October 10, 2017

Re: Norfolk, MA – Abbyville Commons and Preserve at Abbyville
Traffic Peer Review – Second Comment Letter

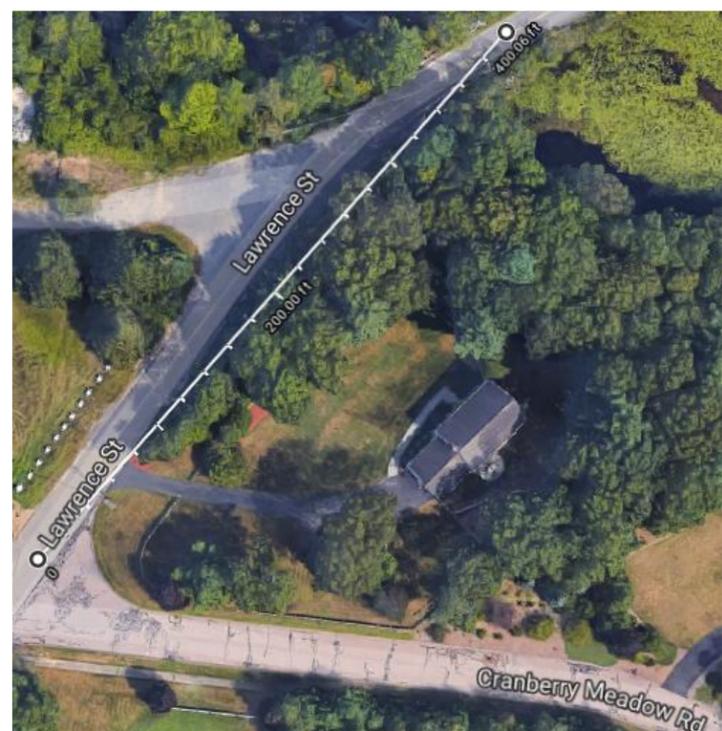
Based on field reconnaissance, however, sight lines may be limited for Lawrence Street eastbound vehicles turning left into the proposed east site driveway (Elliot Boulevard) due to the horizontal alignment of Lawrence Street and the vegetation located along the south side of Lawrence Street. The concern is that vehicles turning left into the site from Lawrence Street eastbound may not be able to appropriately judge the gaps in the Lawrence Street westbound traffic stream and that Lawrence Street westbound approaching vehicles may not have adequate time to react to a downstream turning vehicle into the site. For reference, the picture to the right was taken from

the approximate location of the proposed east site driveway with the area of concern circled. Therefore, we requested that the Applicant's traffic engineer research the existing right-of-way along the south side of Lawrence Street in this area for potential vegetation clearing/trimming to improve safety.

Based on information provided by the Applicant's traffic engineer and our research, however, it appears that sight lines would be significantly less than 400 feet for vehicles turning left from Lawrence Street eastbound into the proposed site driveway opposite Cranberry Meadow Road attempting to see Lawrence Street westbound approaching vehicles. The line drawn on the aerial image to the right is approximately 400 feet from Cranberry Meadow Road (i.e., the location of where Lawrence Street eastbound left turns would turn to the driveway).

In accordance with AASHTO guidelines (Case F – Left Turns from the Major Road), roadways that allow vehicles on a major roadway to turn left across opposing traffic (i.e., at intersections and driveways) should have sufficient sight lines to accommodate this left-turn movement. At three-legged intersections, these types of sight distances should be evaluated especially when located near a horizontal curve or crest vertical curve along the major roadway.

While we agree that the Applicant should coordinate with the Norfolk DPW and Conservation Commission staff regarding any vegetation clearing/trimming, we also recommend that the Applicant's traffic engineer prepare a sight line plan for Lawrence Street vehicles turning left into the proposed east site driveway in accordance with AASHTO guidelines.

As documented in a subsequent October 6, 2017 letter, the Applicant's traffic engineer stated that the horizontal curvature in Lawrence Street located approximately 200 feet from Cranberry Meadow Road and the associated vegetation located along the southern side of Lawrence Street would not limit sight lines to and from the proposed east site driveway (Elliot Boulevard). Further, the Applicant's traffic engineer states that sight distance measurements of over 400 feet can be achieved (that exceeds the minimum requirement for the 85th percentile speeds) even if vegetation extends to the edge of the roadway. Therefore, the Applicant's traffic engineer has determined that no vegetation clearing along the south side of Lawrence is necessary, but the Applicant is willing to work with the Norfolk DPW and Conservation Commission staff in relation to any additional vegetative trimming within the Lawrence Street right-of-way east of the proposed east site driveway.
